GPM Series

Firmware Version 1.02 Release Notes

GE Publication Number: GER-4472

102-1

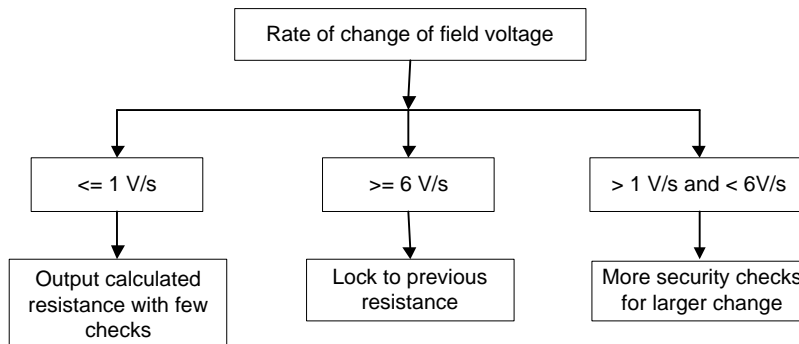
The GPM-F algorithm was reported as generating unreliable Field Ground resistance readings in situations when the field voltage changed rapidly. A large change in field voltage can occur during a large change in generator excitation, however this is normally temporary. The issue caused undesired Field Ground fault alarms or tripping. Through analyzing the source code and data obtained from field, testing and simulations, the reasons were concluded as:

- In the algorithm, the field voltage transient was considered. However, the cut-off rate of Field voltage change threshold was too loose, causing the calculation of Field Ground resistance to have a large error even if the fluctuating field voltage was still in the allowable range.
- In the calculation of Field Ground resistance, there may have been negative values in the presence of a large rate of change of field voltage. There were three reasons for this phenomenon: 1) the field voltage was in a large transient state; 2) a Field ground fault was just occurring and 3) the Field Ground resistance was very small, close to 0. In the algorithm, the negative fault resistance was forcedly set to zero.

The enhanced Field Ground resistance algorithm (Rev 1.02) considers the following aspects:

- When the field voltage is stable (no rapid change in voltage), the Field Ground resistance is output with few security checks, similarly as was done by the previous version of the algorithm. This guarantees the speed and sensitivity of the module.
- When the field voltage is in an allowable transient state, more security checks and calculations are processed to improve the accuracy and security of the module.
- When the field voltage is in a large transient state, the calculated fault resistance is frozen to the previous valid value to guarantee the security of the module.

The figure shows this modification.
